Project Title: Refurbish Elevators and Replace Controls

Solicitation Questions and Answers
for
Refurbish Elevators and Replace Controls
Project: 437-22-101, RFP: 36C26324R0021
12/15/2024

Solicitation Questions and Answers (updated 3-26-2024) for
 Refurbish Elevators and Replace Controls
 Project: 437-22-101, RFP: 36C26324R0021

Drawing Number
AD5.21

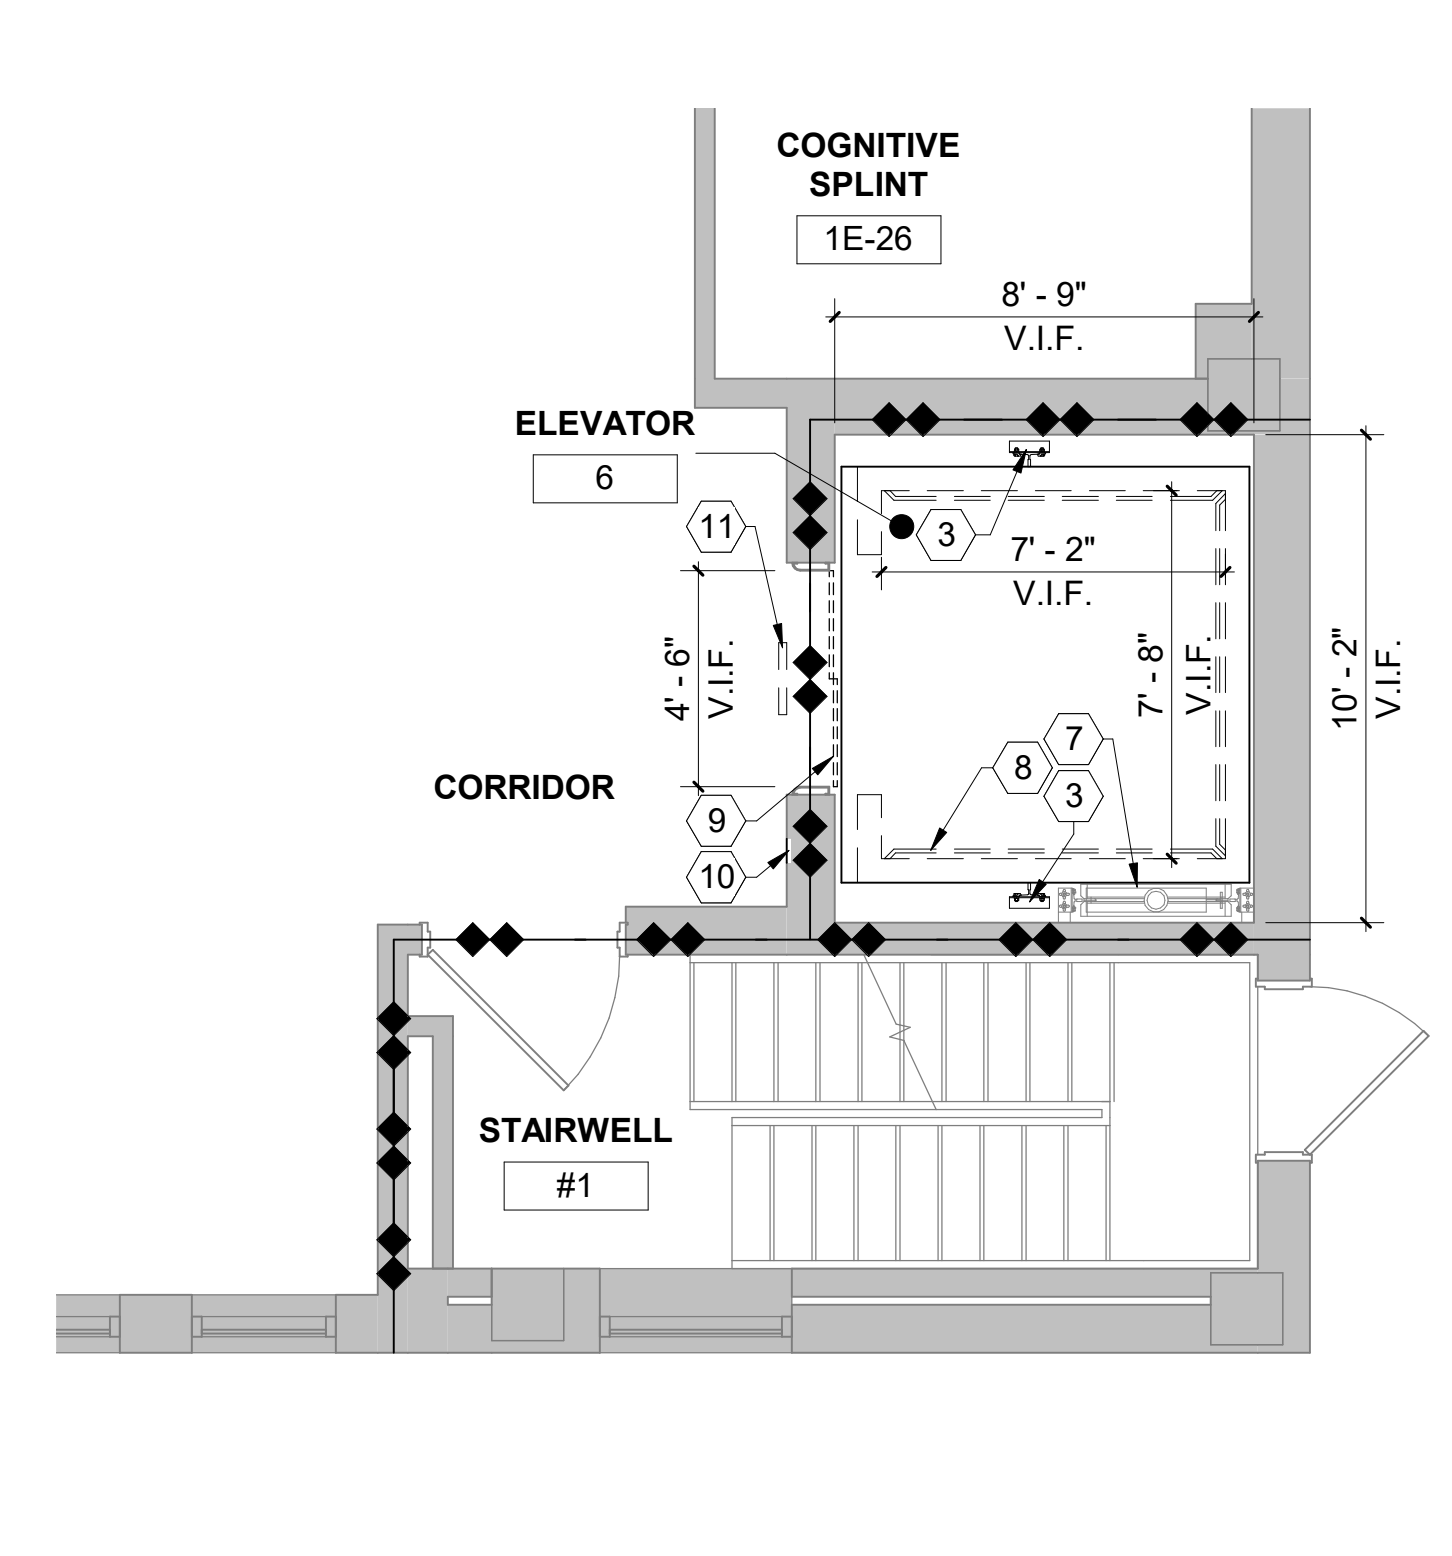
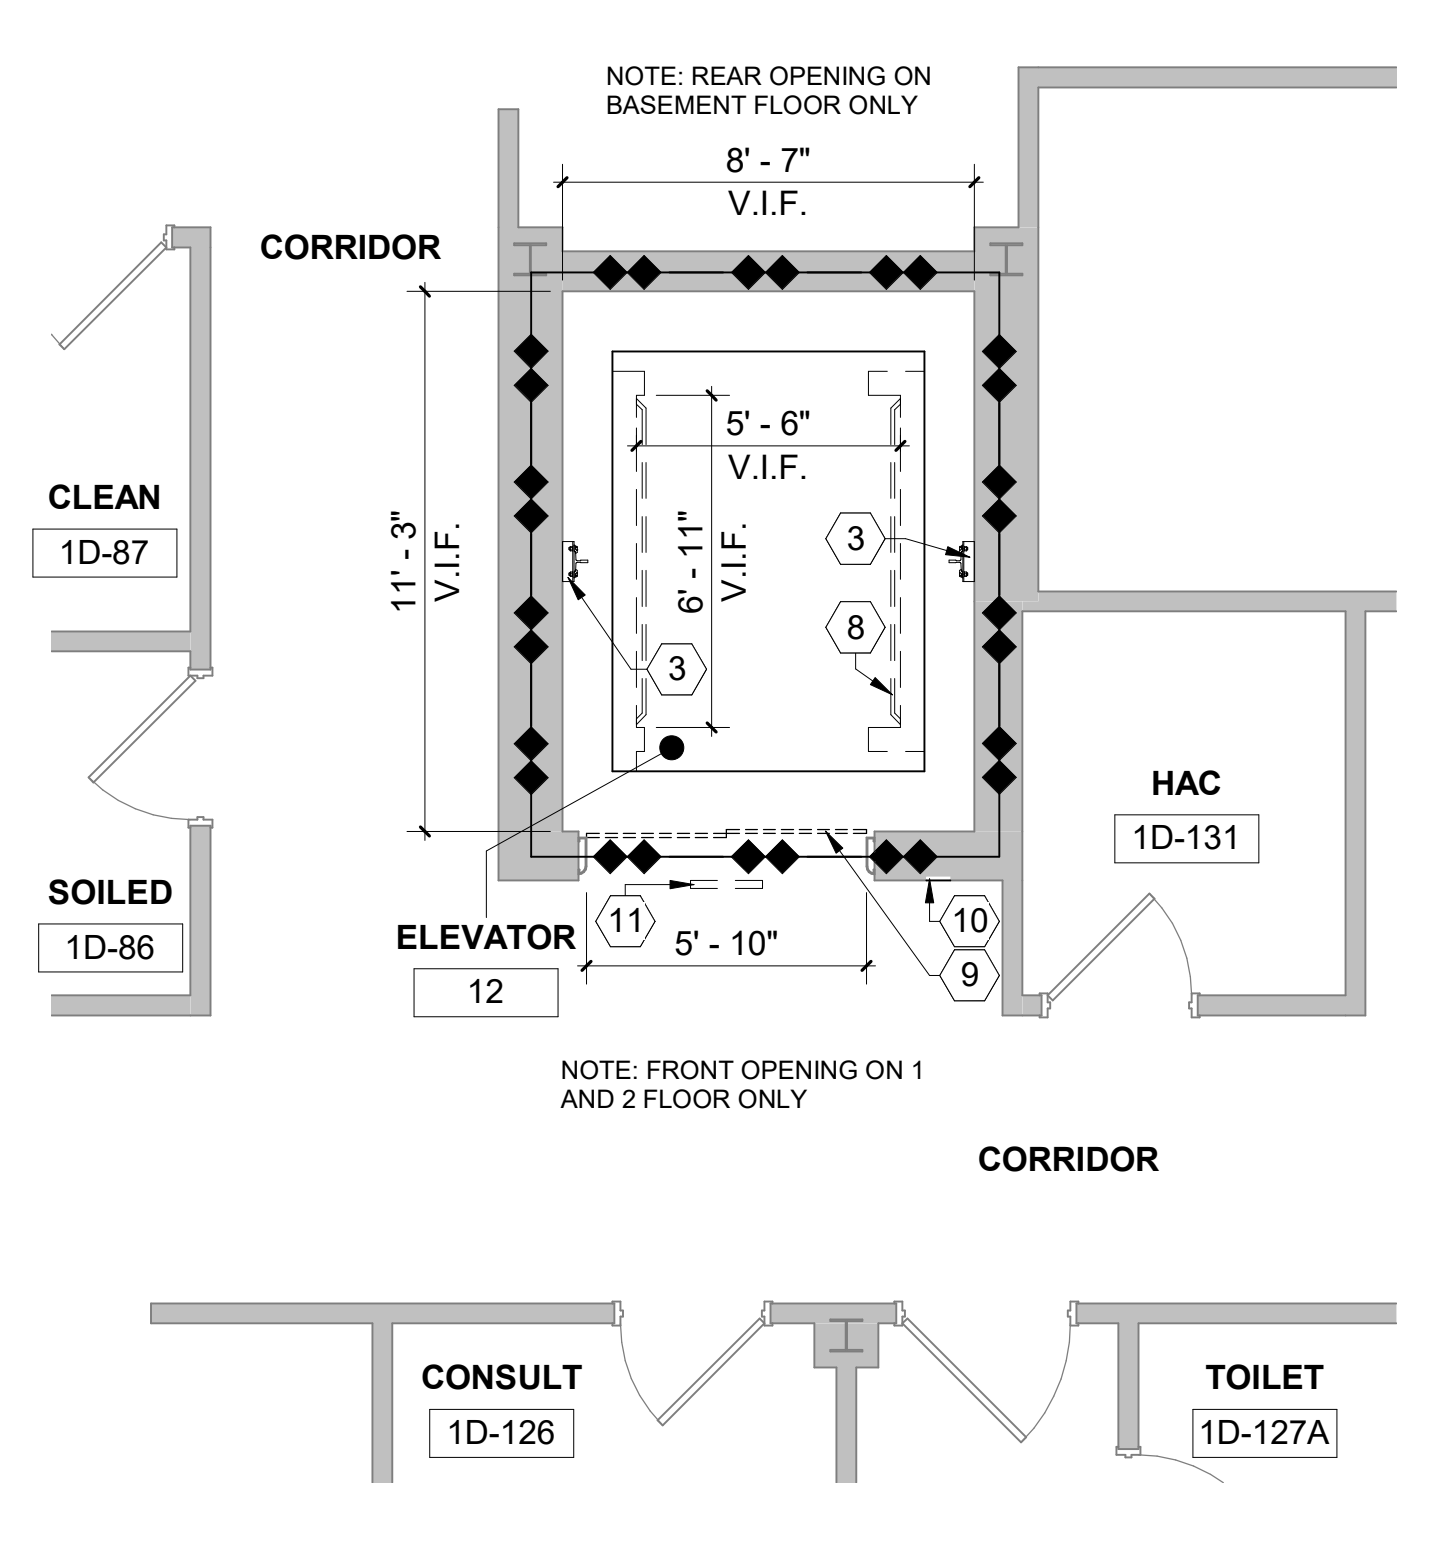
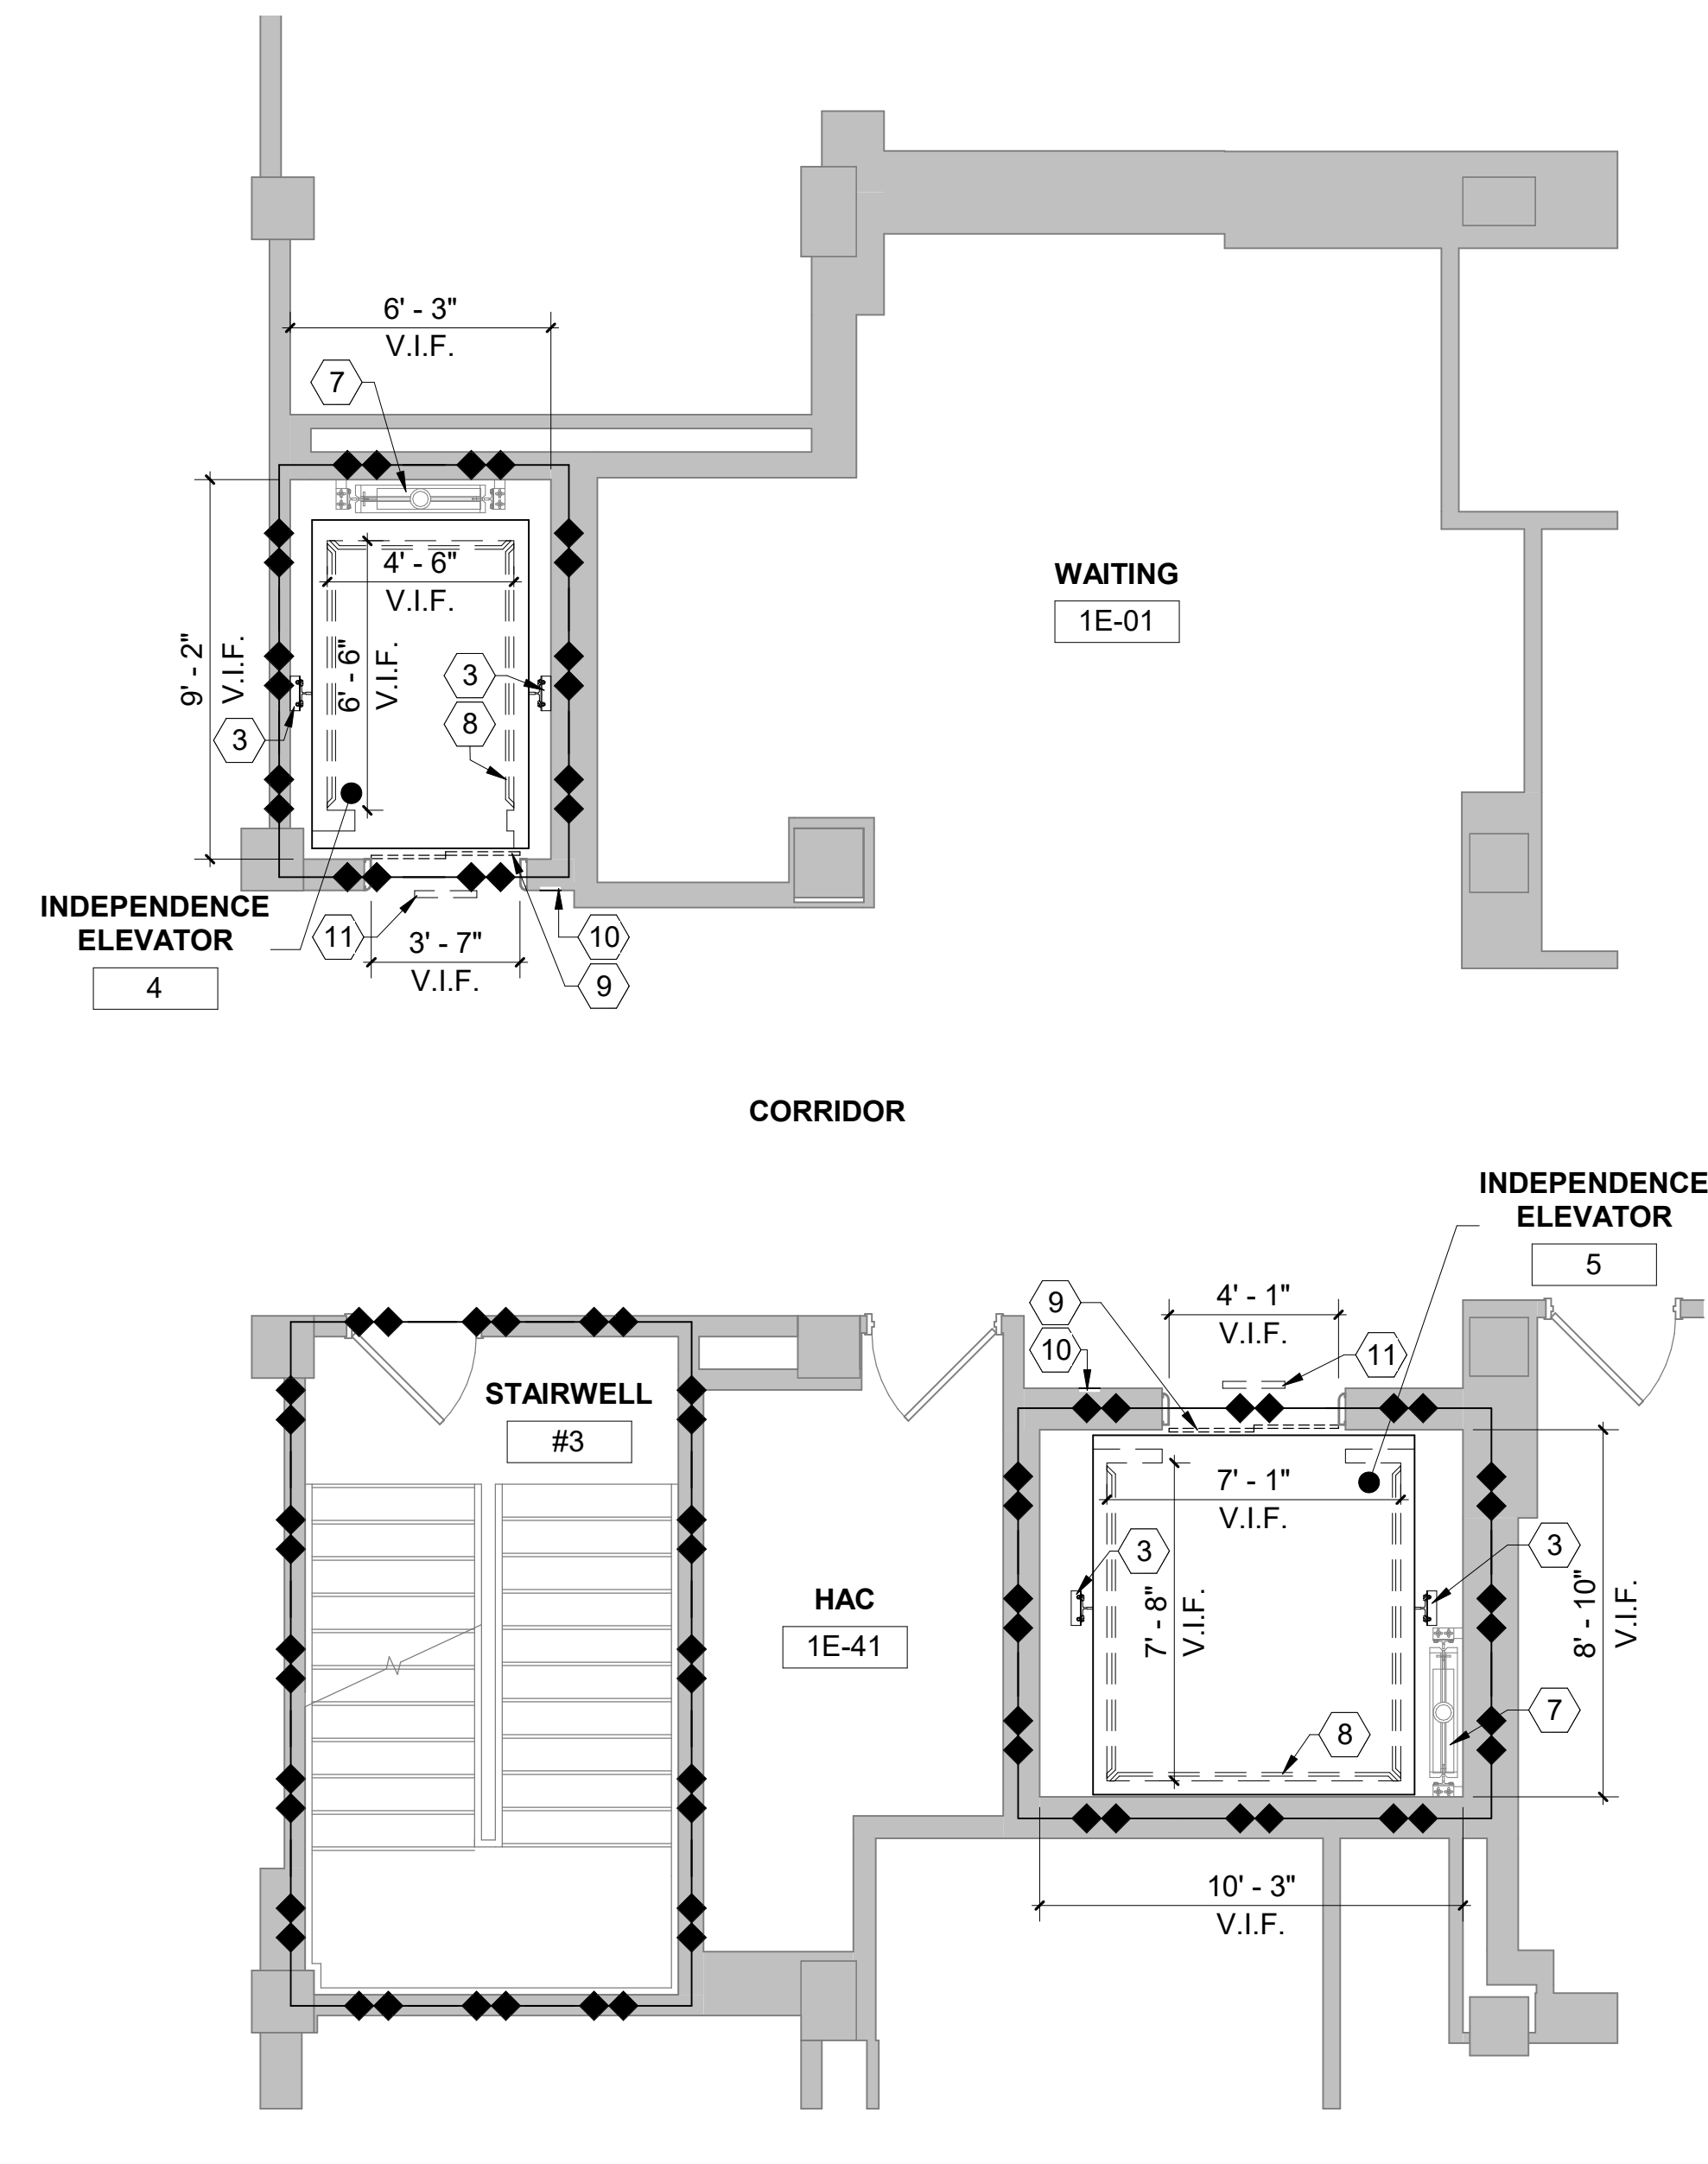
55.	Drawing AD5.21 Key note #14	<p>Replace counterweight assemblies Per the drawings the full counterweights are to be replaced but it is not in the specifications. Which takes precedence?</p>	Note 7 on drawing sheet AD5.20 states that the existing counterweight assemblies are to remain.

56.	Drawing AD5.21 Key note #15	<p>Replacement of the rails on elevators 7&8: During the walkthrough is was discussed by all parties that there might be a revision to the specification to only replace the bottom rail in the car and counterweight stack since that was the only pieces affected by water. Will the specification be revised to include the bottom rail only? Please note removal of the rails will require the entire elevator to be disassembled and removed from the shaft and require and extended downtime.</p>	<i>See Response to Question #47</i>

Drawing Sheet AD5.21 ENLARGED PLANS - DEMOLITION – See revised drawing sheet for the inclusion of additional floor demo to support the installation of underfloor plumbing at Elevator #10.

Drawing Sheet AD5.21 ENLARGED PLANS - DEMOLITION – See revised drawing sheet for the adjustment of keynotes # 3, 9, 14, 15.
